***Delegated Decisions by Cabinet Member for  
Environment (including Transport)***

***Thursday, 11 January 2018 at 10.00 am  
Committee Rooms 1&2 - County Hall, New Road, Oxford OX1  
1ND***

## **CABINET MEMBER FOR ENVIRONMENT – 11 JANUARY 2018**

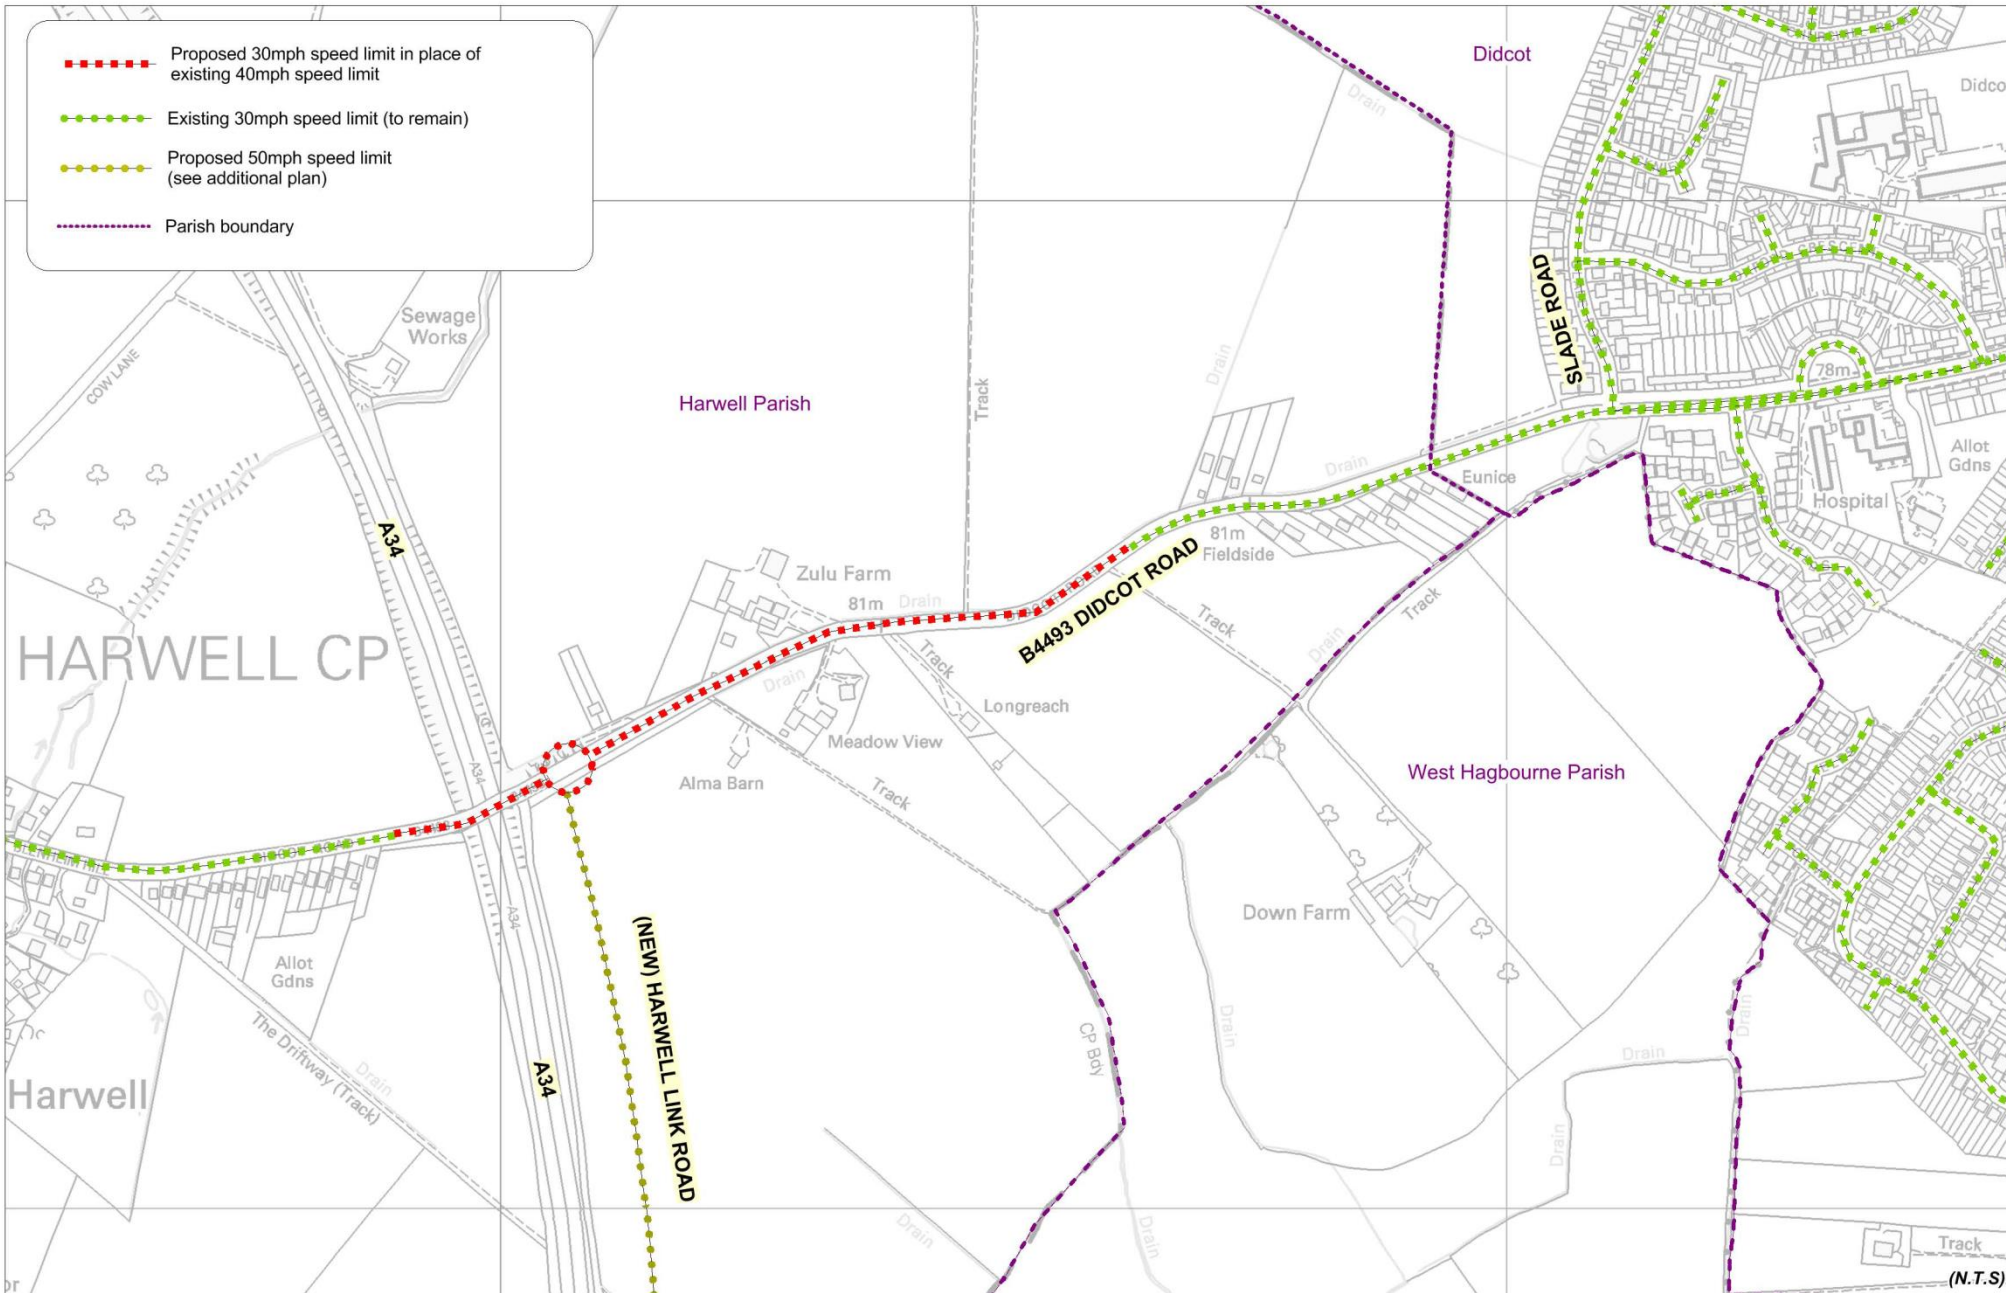
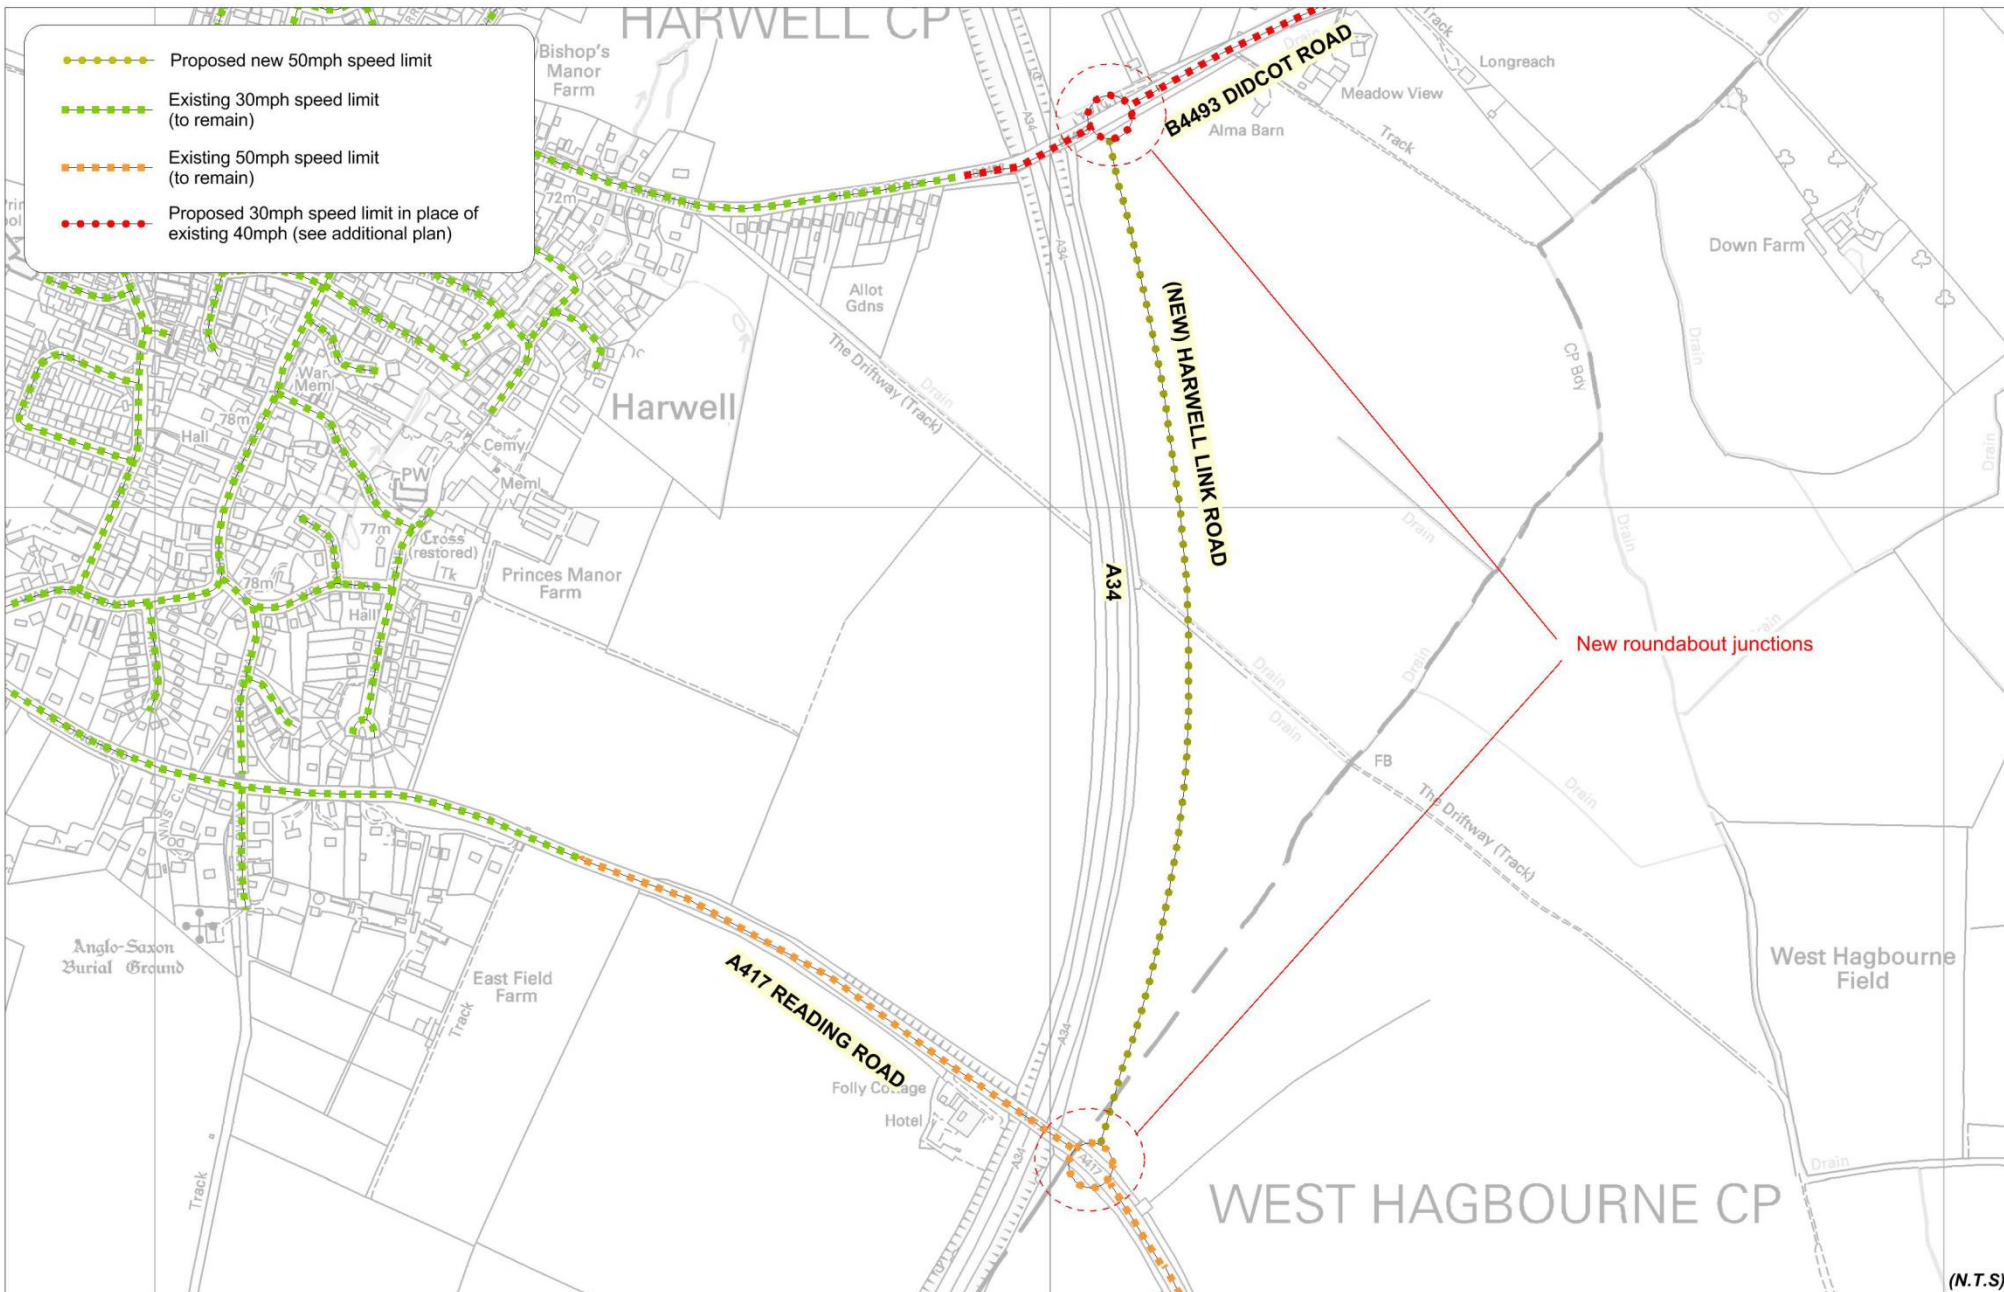
RESPONDENT	SUMMARISED COMMENTS
(1) Didcot Town Council	<p><u>Proposed 50mph</u> – <b>Neither</b> - As a new road, Didcot Town Council does not see a need for the speed limit to be set below 60mph.</p> <p><u>Proposed 30mph</u> – <b>No objection</b> – Although Didcot Town Council wishes to raise a wider concern about Oxfordshire County Council’s priorities regarding road safety. It would prefer that the County Council not pursue ad hoc reductions in speed limits and instead agree to implement necessary road safety measures outside of Didcot’s schools.</p>

(3) Local Resident, (The Cleave, Harwell)	<p><u>Proposed 50mph</u> - <b>Support</b> – The northernmost 100 metres of the link road should be part of the 30mph limit for the B4493, rather than having the limit change to 30mph at the roundabout itself. This would help pedestrians who will need to cross the link road at the roundabout when using the footpath along the B4493 to/from Harwell.</p> <p><u>Proposed 30mph</u> - <b>Support</b> – (Same as above)</p>

(5) Local Resident, (Barrow Lane, Harwell)	<p><u>Proposed 50mph</u> - <b>Object</b> – Having a 50mph limit on this section of road, directly adjacent to the 30 limit on the Didcot-Harwell Road will simply encourage speeding along the other sections. This also applies to the exit into the new</p>

<p>development at Valley Park from the link road; expecting traffic to jump from 50mph to 30mph with no other modifications to the 30mph section is fantasy land. 40mph would be a far more sensible limit for the link road.</p> <p><u>Proposed 30mph</u> - <b>Support</b> – Please look at narrowing the road along this section to better fit the reduced speed limit and allow for natural enforcement. This could be achieved via some nice wide segregated cycle tracks.</p>

(10) Online response, (unknown)	<p><u>Proposed 50mph</u> - <b>Object</b> – I am a frequent cyclist, and a slower speed limit will do nothing to stop cars / HGVs behaving aggressively to cyclists. Instead cyclists need to be aware of their rights and attend training courses if they feel they are being intimidated by cars / HGVs to improve their confidence. Wasting public money on providing lighting and lowering the speed limit is overkill, as the cyclist anyway has to be able to cope with the next road junction where the speed limit increases once more and the lighting disappears. Police should be stationed to observe aggressive driving against cyclists, with stiff on the spot penalties enforced, and with training provided to offenders of what rights a cyclist has.</p>

(20) Local Resident, (High Street, Milton)	<p><u>Proposed 50mph</u> - <b>Neither</b> – <i>No comment.</i></p> <p><u>Proposed 30mph</u> - <b>Object</b> – I would suggest a better strategy for improving the cycle network would be an investment in designated cycle paths like the excellent ones running beside the new developments in that area of Didcot. This stretch of road has wide verges where a small extension to the road width or a specific separate cycle path running alongside would surely be a better solution for all users. I'd suggest looking for the best not the easiest solutions (if lowering speed limits would in fact have any benefit whatsoever) to improving cycling in the region.</p>

<p>(22) Local Resident, (Western Avenue, Milton Park)</p>	<p><u>Proposed 50mph</u> - <b>Object</b> – What is the point of reducing the speed limit full time when the only problems are during rush hour and then you cannot achieve the speed limit anyway.</p> <p><u>Proposed 30mph</u> - <b>Support</b> – This road is now becoming part of Didcot and therefore should be reduced in the near future.</p>
<p>(23) Local Resident, (Merton Close, Didcot)</p>	<p><u>Proposed 50mph</u> - <b>Neither</b> – <i>No comment.</i></p> <p><u>Proposed 30mph</u> - <b>Support</b> – <i>No comment.</i></p>
<p>(24) Local Resident, (Abbott Close, Didcot)</p>	<p><u>Proposed 50mph</u> - <b>Neither</b> – Seems reasonable, seeing as it is in-line with the speed limit of the Reading road. But equally, visibility will be very good (I assume), seeing as the road is roughly straight. I also assume it will be reasonably wide seeing as there is nothing around it. This road could (possibly should?) be a national speed limit seeing as there is no housing nearby.</p> <p><u>Proposed 30mph</u> - <b>Support</b> – This is a no-brainer with all of the additional housing and the nearby college. The consistency of a solid 30mph speed limit along this length of road also means that there is potentially less confusion/lax driving.</p>

7. The response from Thames Valley Police is noted, and it is confirmed that a speed survey will be carried out on the link road following its opening. In respect of Didcot Town Council's comment that the new link road should have been designed to accommodate the national speed limit, land and other constraints relating to the alignment of the new road did not make this feasible.

9. In respect of the above objections and comments, it is considered that the proposed 50mph speed limit is appropriate taking account of the alignment of the new link road and similarly that the terminal point just south of the new roundabout junction with the Harwell-Didcot road is consistent with normal practice.

11. The above objections in relation to cycling are noted, but while it's accepted that further measures to improve safety for cyclists are desirable, these objections are not considered a reason for not progressing the 30mph speed limit. Similarly the concern over additional journey time is noted but taking account of the extent of the proposed change, this is not considered to be a significant issue.
